Access Compliance Report Public Rights-of-Way (Curb Ramps)

Main Street: YELLOWTAIL_DR		Cross Street: SILVER_FOX_RD		Location:	NW
ADA ID: RPRK211206164726	Ramp Type: Type 4 - Parallel	Initial Pass/Fail: Fail	Overall Compliance: No	Severity Score:	30
Codes/Mitigation Info/Possible Solution			Field Measurements/Component Compliance

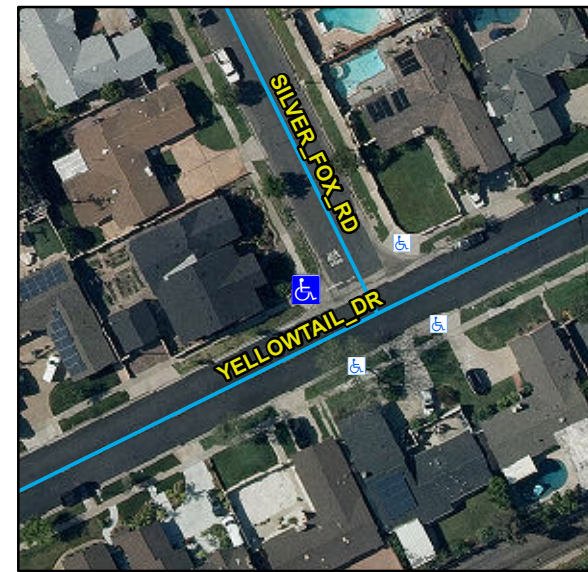
Compliance	Description	Data	Compliance	Description	Data
N/A	Ramp Length LT (in)	107	N/A	Ramp Length RT (in)	111
Yes	Ramp Width LT (in)	124	Yes	Ramp Width RT (in)	124
Yes	Ramp Run Slope LT (%)	2	Yes	Ramp Run Slope RT (%)	6
No	Ramp Cross Slope LT (%)	6	No	Ramp Cross Slope RT (%)	10.3
N/A	Landing Present	N/A	N/A	DWS Provided	N/A
N/A	Landing Length (in)	N/A	N/A	DWS Contrast	N/A
N/A	Landing Width (in)	N/A	N/A	DWS Length (in)	N/A
N/A	Landing Run Slope (%)	N/A	N/A	DWS Full Width	N/A
N/A	Landing Cross Slope (%)	N/A		DWS Offset Type	N/A
N/A	Landing Movement Obstructed?	N/A	N/A	DWS Offset Left (in)	N/A
	Landing Movement Type	N/A	N/A	DWS Offset Right (in)	N/A
N/A	Landing Shared	N/A			
N/A	Clear Space	Yes			
N/A	Clear Space To Crosswalk (in)	N/A			
N/A	Marked Crosswalk 1	No	N/A	Marked Crosswalk 2	No
	Crossing 1 Direction	S		Crossing 2 Direction	E
	Marked Crosswalk 1 Width (in)	N/A		Marked Crosswalk 2 Width (in)	N/A
N/A	Ramp Inside Crosswalk 1	N/A	N/A	Ramp Inside Crosswalk 2	N/A

Remove & Replace Curb Ramp With Two New Directional Ramps or Equivalent.
